November 4, 1999

Subject: Agency Response Letter
New Genico Site
3927 East 14th Street
Oakland, California

Our office has received and reviewed the two documents; **ASTM Tier 2 RBCA Analysis Amendment and the Second Quarter 1999 Groundwater Monitoring Report** by ATC Associates and Kleinfelder, respectively. This letter serves to comment on both of these reports.

ASSOCIATES INC. <small>ENVIRONMENTAL, GEOTECHNICAL AND MATERIALS PROFESSIONALS</small>	
GROUNDWATER ELEVATION CONTOUR MAP (SEPTEMBER 23, 1999) NEW GENICO 3927 E. 14th Street Oakland, California	
Project No. 61137.0008

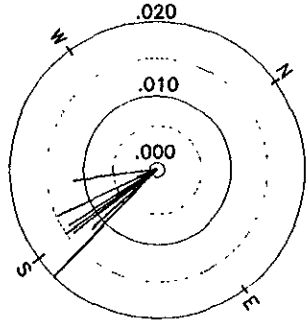
ACHCS Request: "Please provide a rose diagram of the historical groundwater flow direction at this site. This will be used to support not evaluating exposure to residential properties."

Response: A copy of a rose diagram on the most recent groundwater elevation contour map prepared by ATC is included as **Attachment B**.

Chart 1. Oxygen Concentrations with Groundwater Hydrograph for Well HMW-1

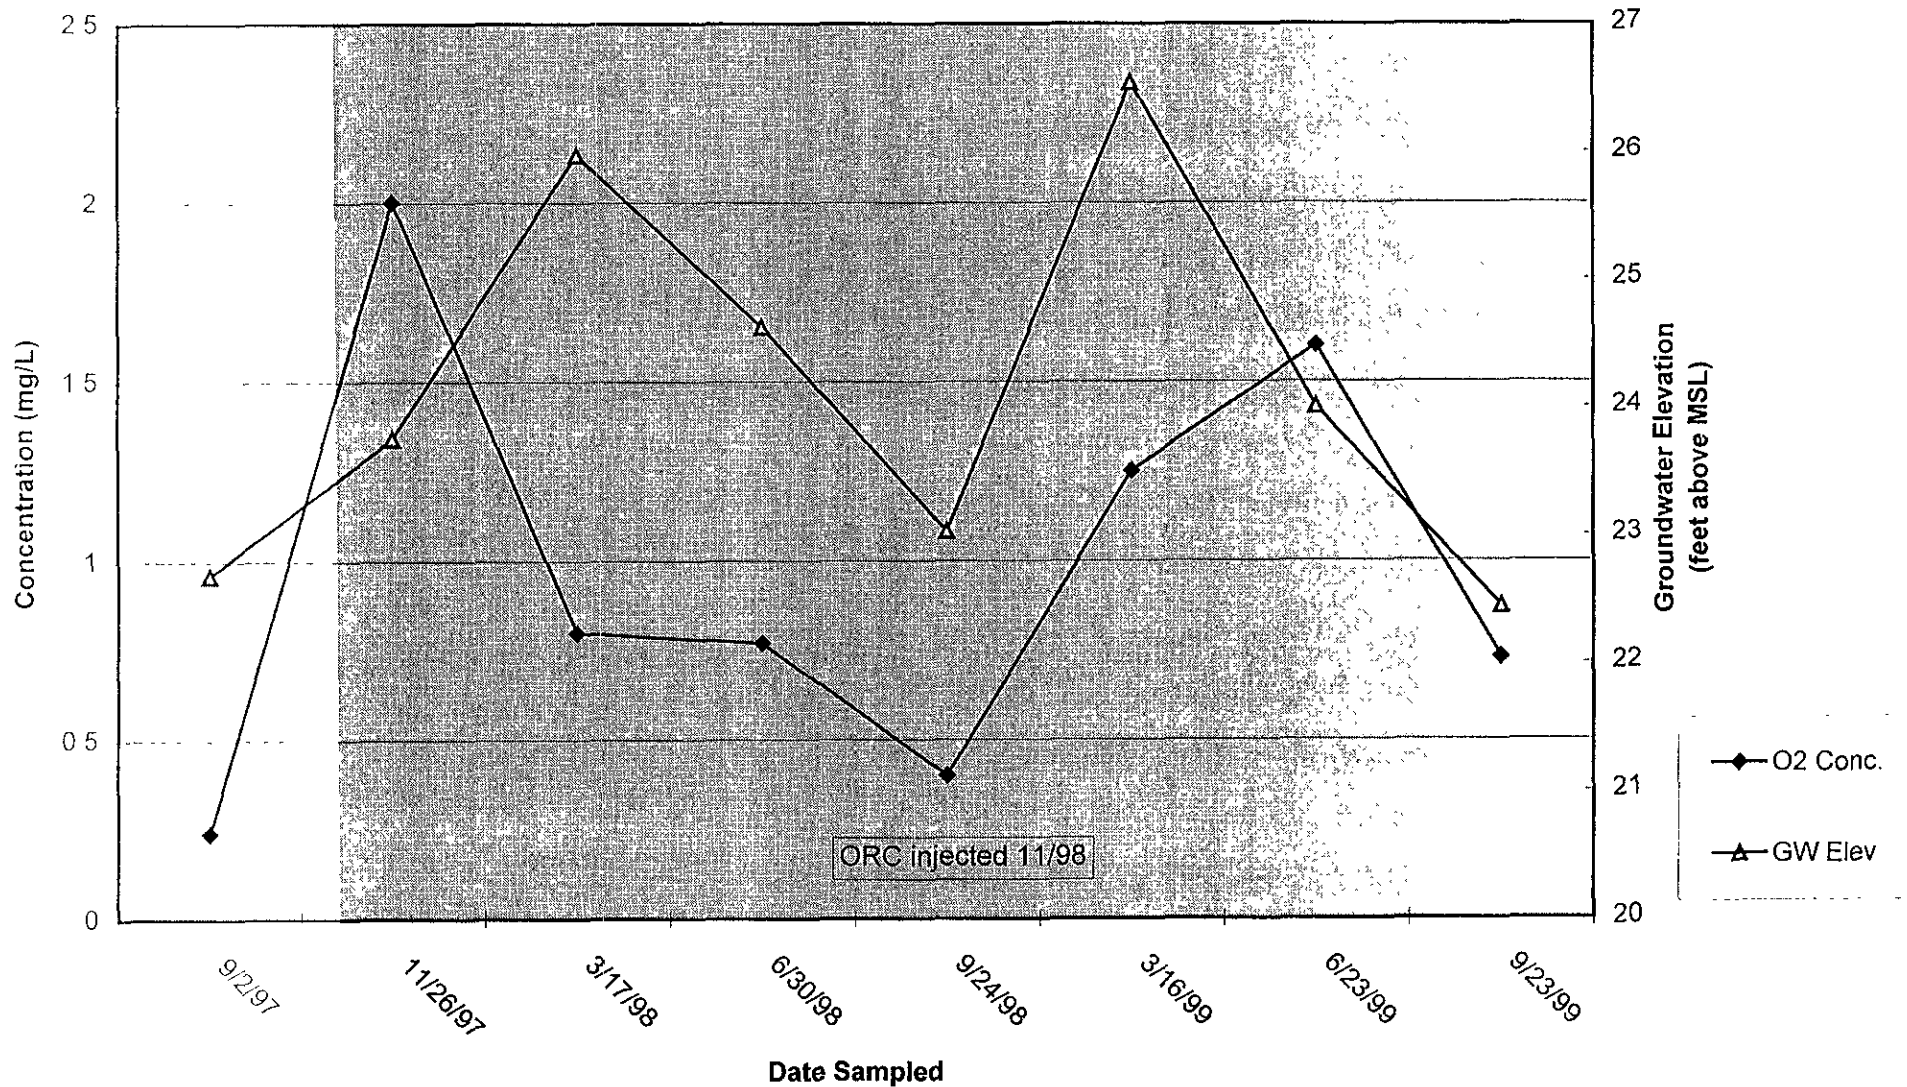
After ORC inject. DO went from ~0.4 to 1.25 to 1.6 ppm, hardly significant

Response: ATC has prepared charts depicting oxygen concentrations and groundwater elevations vs. time. The charts are included in **Attachment C**. As depicted on Chart 1, Chart 2, Chart 3, and Chart 4, it appears that in November 1997, the oxygen concentrations were as high as 2.5 milligrams per liter (mg/l) and in June 1998, the oxygen concentrations were as high as 3.7 mg/l. Thereafter, the concentrations generally decreased until the injection of Oxygen Releasing Compound (ORC) in November 1998. The November 1997 and June 1998 reported concentrations may not be representative of actual levels of oxygen in groundwater beneath the site. These above average oxygen concentrations may be attributed to field personnel taking the oxygen readings after the monitoring wells had been purged, which would render erroneous oxygen readings. At the time these above average readings were recorded, monitoring for biological parameters was still relatively new, and proper protocol may not have been followed. Following the injection of ORC, the oxygen concentrations in all four monitoring wells increased until June 1999. Thereafter, the oxygen concentrations decreased. This decrease may or may not be attributed to the depletion of the ORC in the groundwater.

Chart 2. Oxygen Concentrations
with Groundwater Hydrograph for Well HMW-2

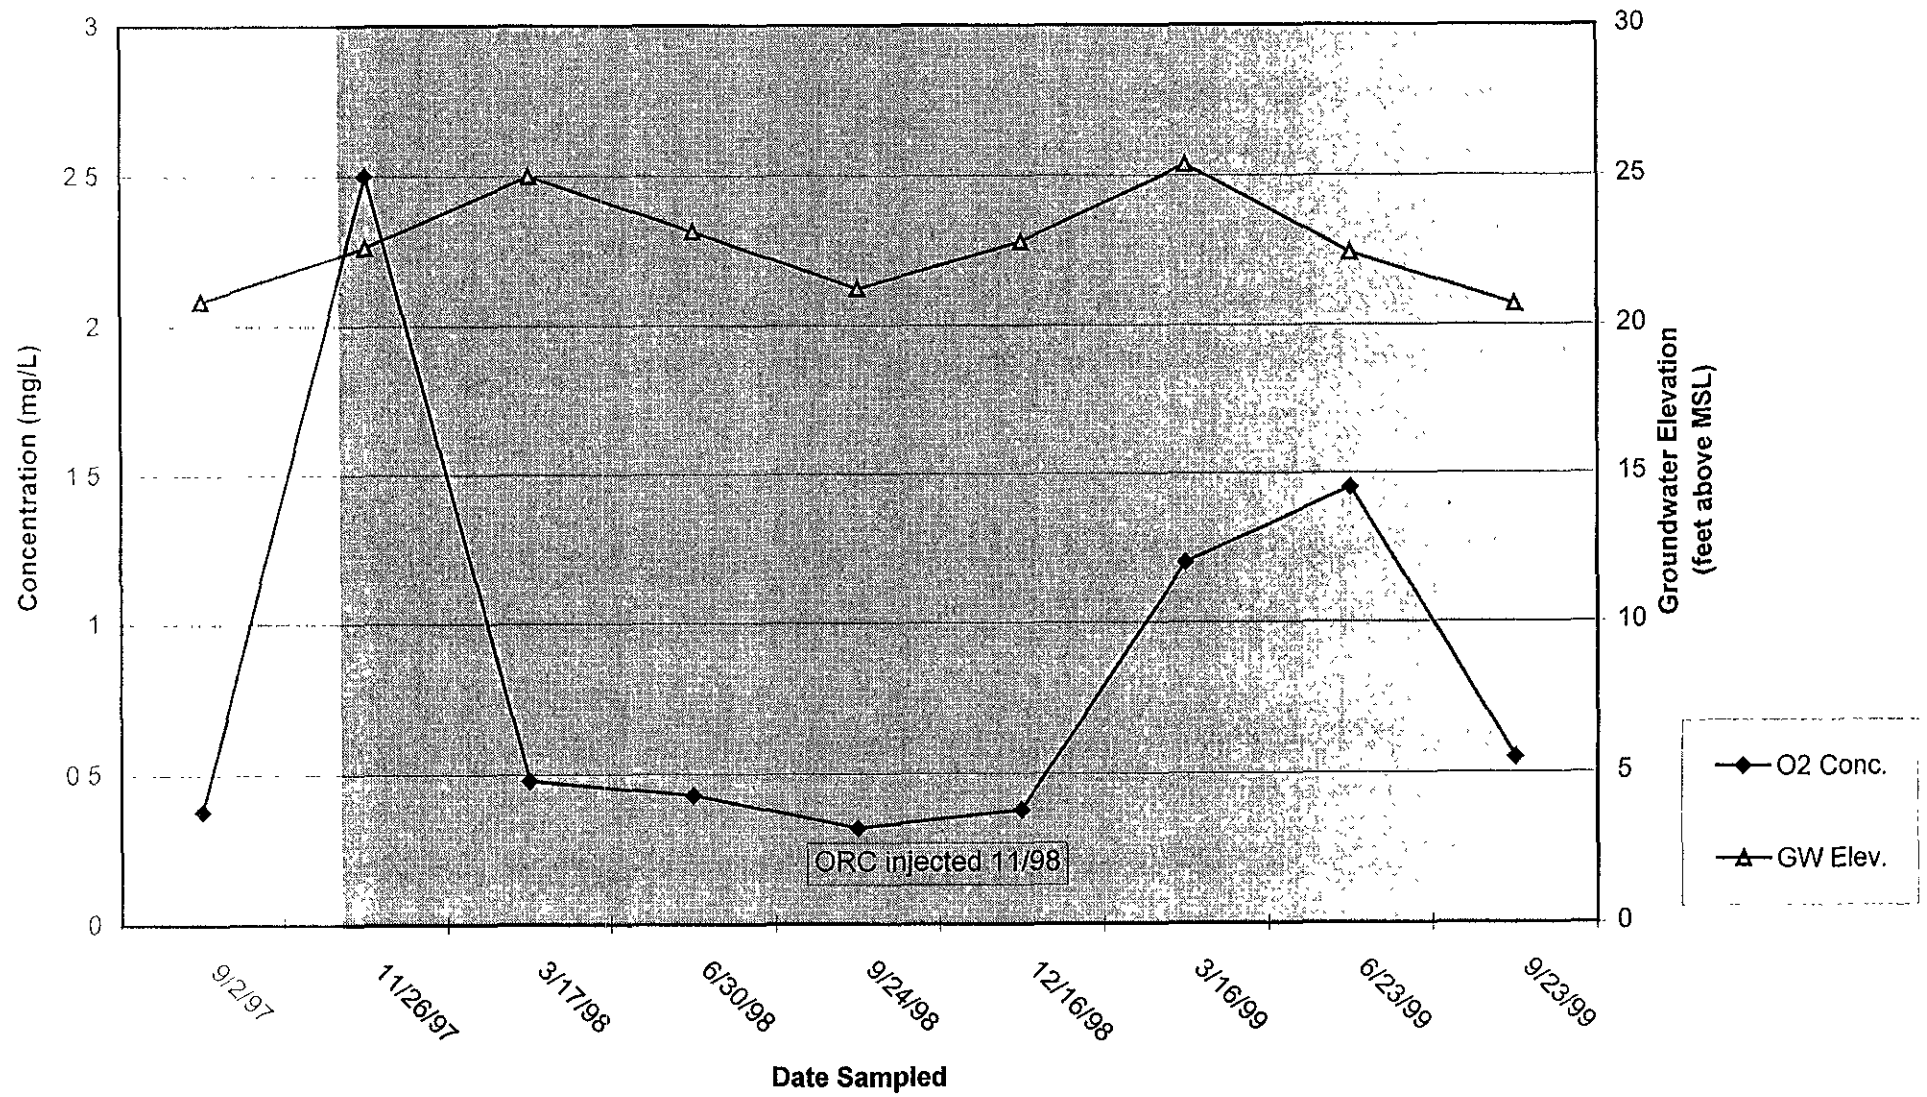
HMW-2 is so far from ORC inj
that you wouldn't expect an increase
in D.O.

Chart 3. Oxygen Concentrations
with Groundwater Hydrograph for Well HMW-3

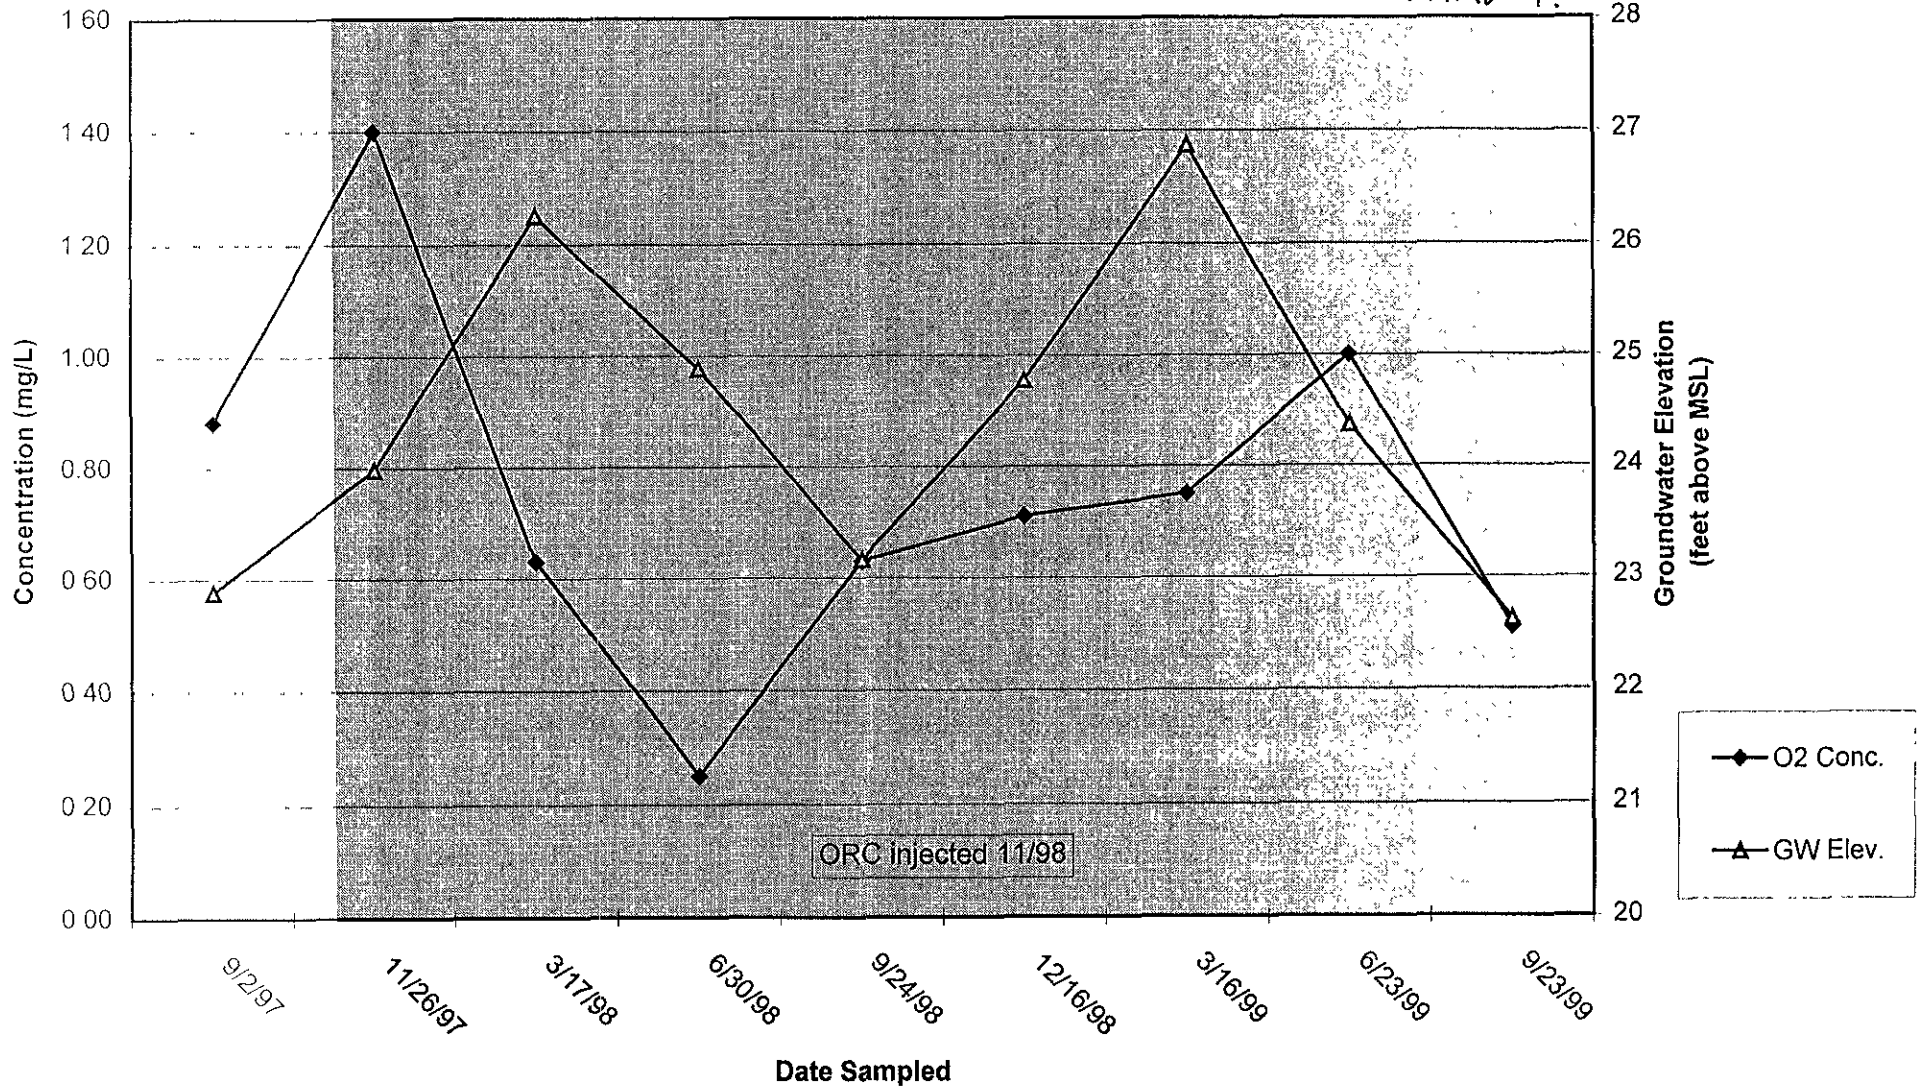
*also upgradient / Bg
these are similar to that
in HMW-1.*

Chart 4. Oxygen Concentrations
with Groundwater Hydrograph for Well HMW-4

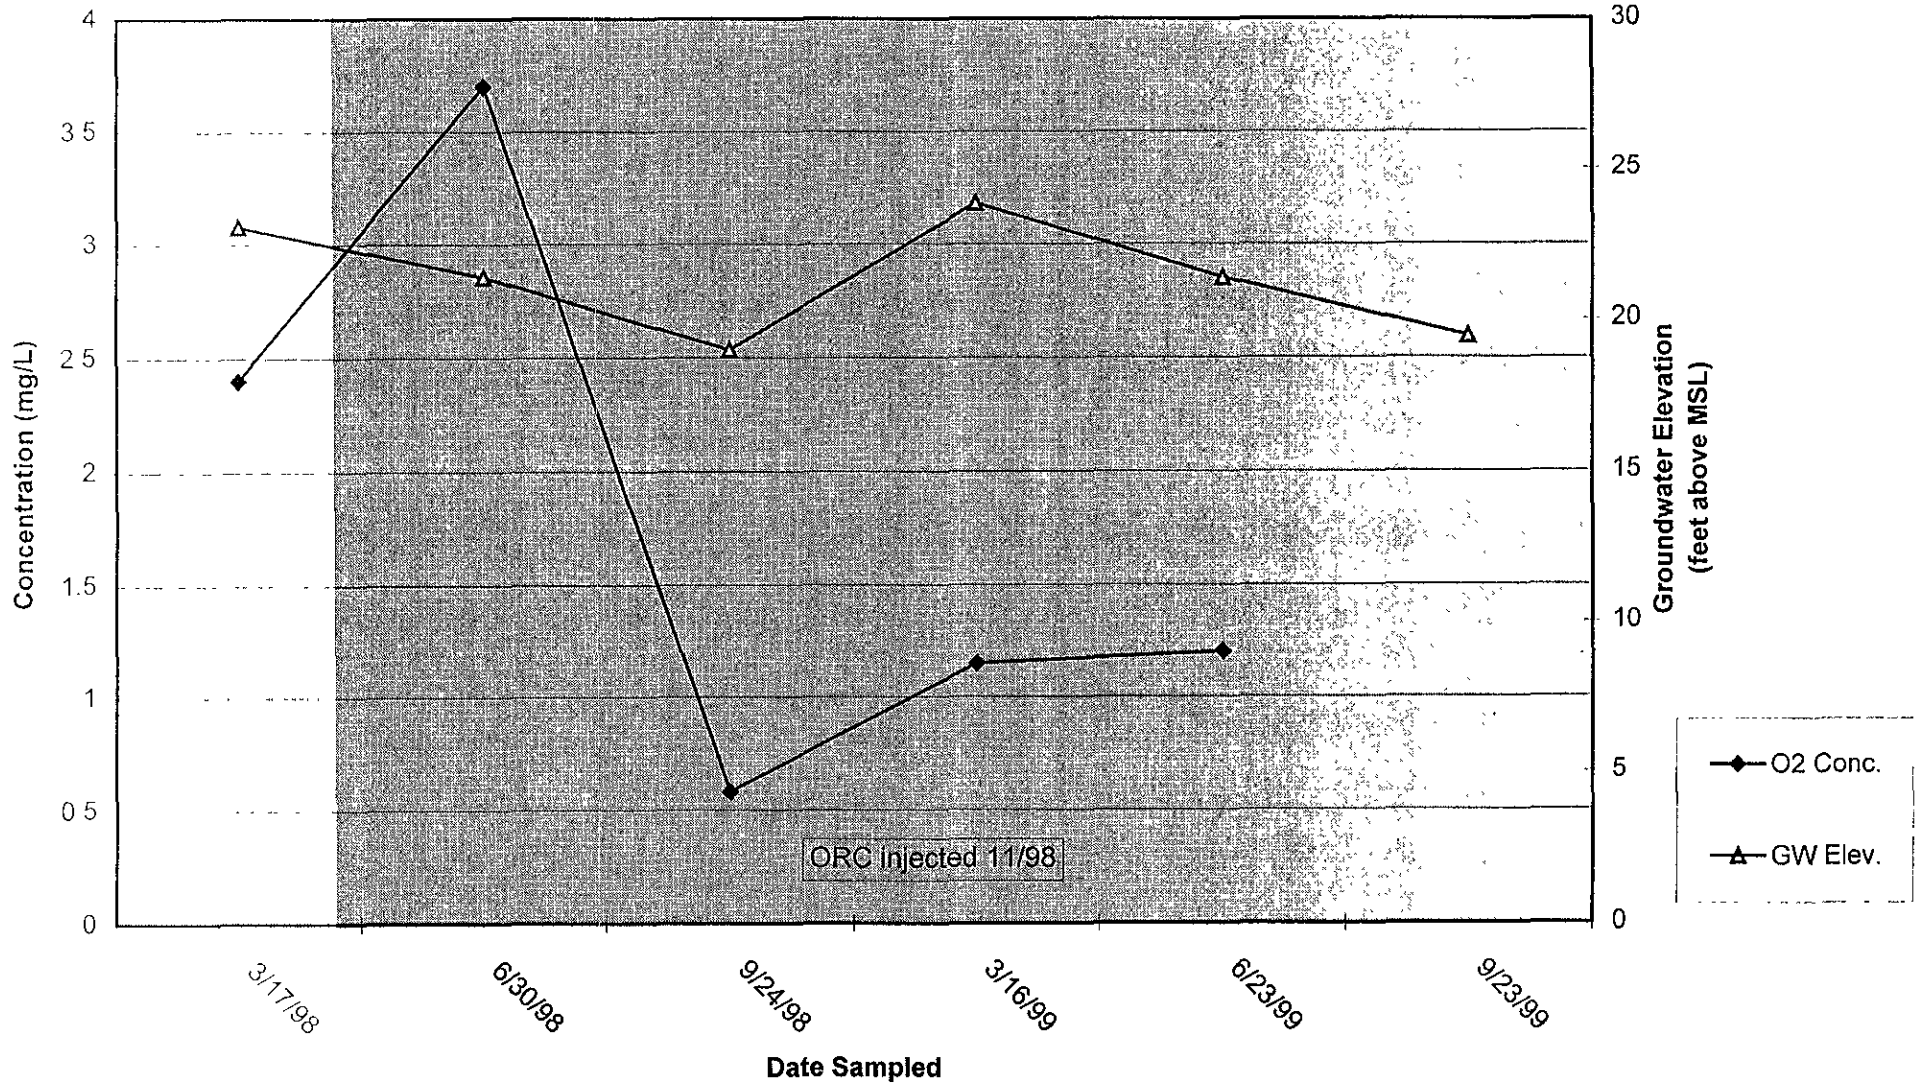
*For Groundwater & [DO] levels
through injection area*
